Environmental Review Team Report

# Savin Industrial Subdivision

Waterford , Connecticut

ENVIRONMENTAL REVIEW TEAM REPORT  
ON  
SAVIN INDUSTRIAL SUBDIVISION  
WATERFORD, CONNECTICUT

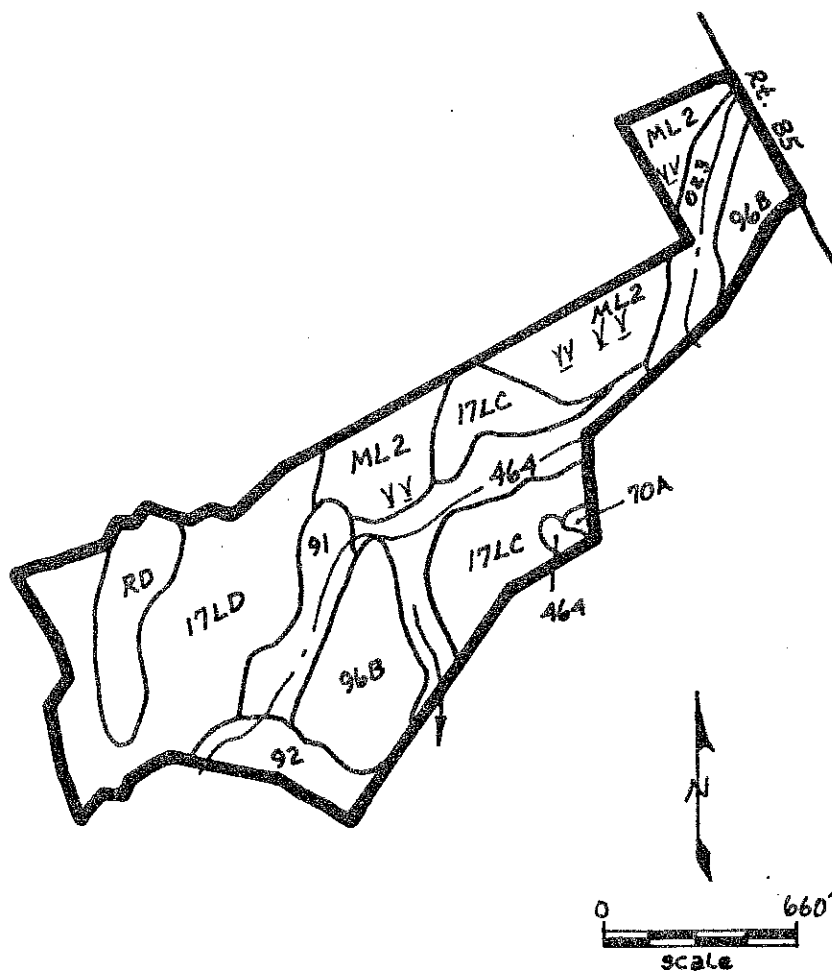
Traffic and circulation appear to cause some of the most noticeable problems with the current proposal. Since there is no way of knowing the size or types of uses that would be attracted to the subdivision, it is not possible to forecast precisely the traffic it will generate. We can only assume that the 14 potential uses will produce high volumes of traffic.

At the present time, plans for the proposed extension of Route 11 southward beyond Route 82 in Salem indicate a widening of Route 85 to four lanes between Route 52 (the Turnpike) and I-95 in Waterford. This is not envisioned as a non-access road, but certainly the number of accesses should be kept to a minimum. The proposed access to the subdivision lies only 500 feet south of the Jayfro access road and about 800 feet north of Cross Road. It would be in the best interests of both the Town and future employees in this subdivision to obtain access to the site from Cross Road. If this is not possible, a joint access with Jayfro would be better than adding another major access point on Route 85. Depending on how this were arranged, it might eliminate the need to construct an additional crossing of Jordan Brook.

The Jayfro site was originally a part of the tract now proposed for development. Its site plan appears to have been approved with no consideration for the possible future development of adjacent land. Now a similar approach is proposed. If the proposed subdivision is approved, successfully developed (in spite of the site preparation difficulties), and successfully marketed, the possibilities of adjacent land being similarly developed are very good. It is, therefore, important to anticipate access requirements of these adjacent lands. The proposed cul-de-sacs are both proposed in locations at least 300 feet from the nearest boundary

of the site. It may be desirable to have one or both of these extended to the property line in order to provide the opportunity to develop an interior circulation system in the Waterford Triangle area.

As presently proposed, the access arrangement could prove hazardous. Many subdivision regulations limit the length of cul-de-sacs, or dead-end roads, to distances ranging generally between 600 and 1,200 feet. (The Waterford Subdivision Regulations state: A cul-de-sac shall not exceed eight hundred feet in length unless it is of a temporary nature and is planned for extension and can reasonably be expected to connect with an existing or proposed road on adjoining land".) The reason for the limitation is safety, and it simply implies that there should be some limit on the number of people (or properties) dependent on a single route of access and egress for themselves and vehicles serving them, particularly emergency vehicles. The proposed subdivision could eventually have a dozen or more industries, employing several hundred persons, all served by a single access route.
